Re: 06V-258, 06V-259, 06V-279

Bulletin Number: V-06-02  
Model Years: 2006

### SUBJECT: Rear Axle Failure on 2006 Vegas<sup>®</sup>, Vegas Eight Ball<sup>™</sup> and Kingpin<sup>™</sup>

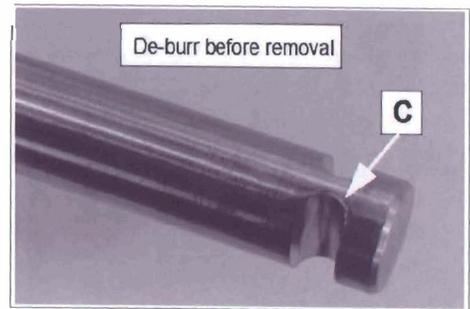
7. Before removing the axle, inspect it closely in area (C) for any burrs or raised edges that may have formed by contact with the retainer plate. Be sure to check both top and bottom side of the axle. Remove any burrs or raised areas carefully using a file or a small hand grinder.
8. Clean any metal shavings from the axle.
9. Draw axle out LEFT side.
